TERENCE
O'ROURKE

Application reference: WSCC/011/21

Ford Circular Technology Park

FORD ERF AND WSTF

The data for Church Lane relates to the links 14-9 and 9-14 as shown on the link diagrams in the Transport Assessment and Figure 15.1 of the ES, 14 being the site access and 9 being the A259 roundabout, capturing the whole of Church Lane. See extract from Figure 15.1 of the ES below.

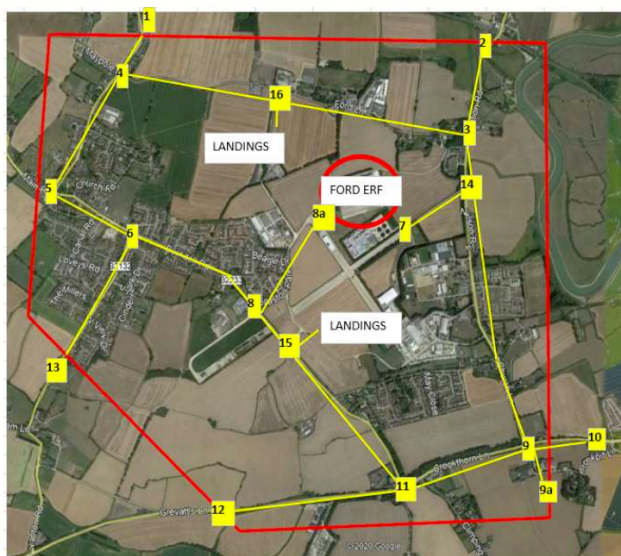
Table 14.17 does not seem to show data for the stretch of road from the site access to Horsemere Green Lane, just from south of there to the A259

As the two-way flow data are needed for noise calculations, the flows for the northbound and southbound contributions were summed, however, the description in table 14.17 associated with this refers to 'Church Lane south of Horsemere Green Lane'.

This reference is not accurate, and we confirm that the noise assessment against this heading includes the total flow from south of the site access road down to the A259 roundabout and vice versa, in line with links 14-9 and 9-14 from the Transport Assessment data that was used to carry out the noise assessment.

PROJECT		FORD CIRCULAR TECHNOLOGY PARK	
DRAWING		Gabion Wall Types Layout	
FOR PLANNING		-	21/09/06 Issued for planning
1:500@A1	21/09/06		
SCALE	DATE		
1404 PL109	-		
DWG. NO.	REVISION

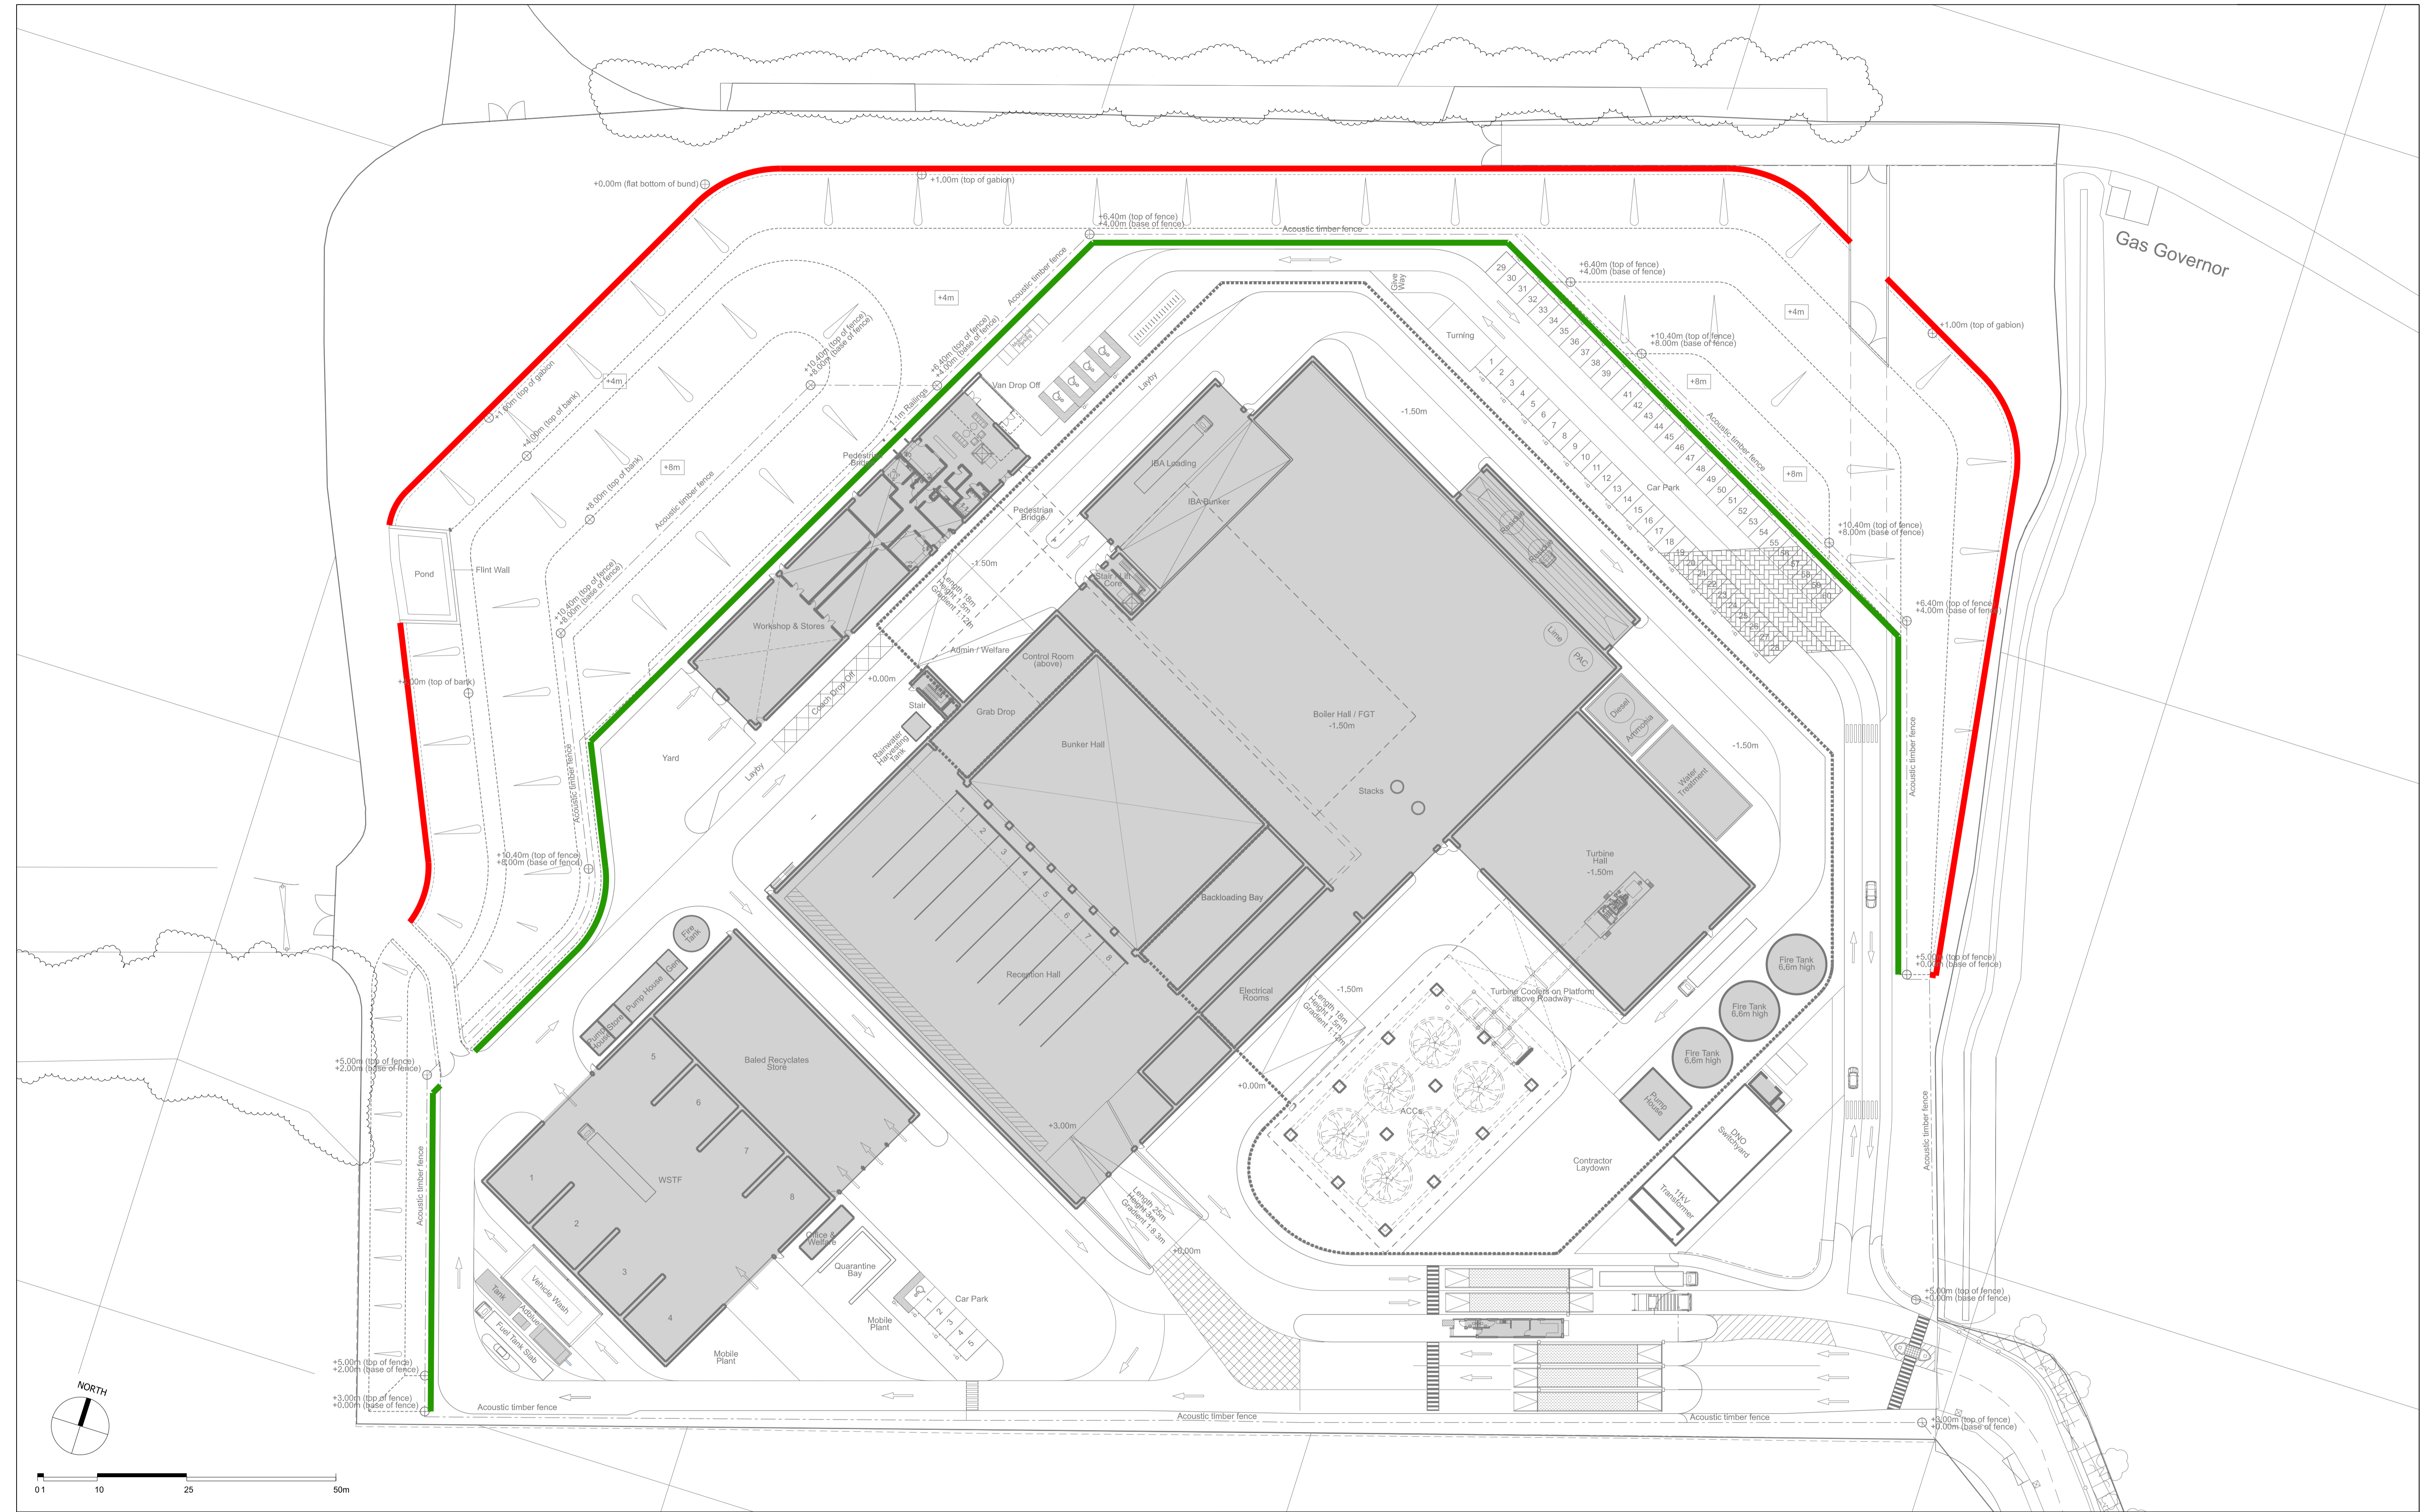
Gabion/flint walls clarification; which are knapped flint, which are rock filled gabions

See the attached drawing clarifying that the knapped flint faced gabions are those that face outwards towards the site boundary, and the rock gabions are those that face internally.
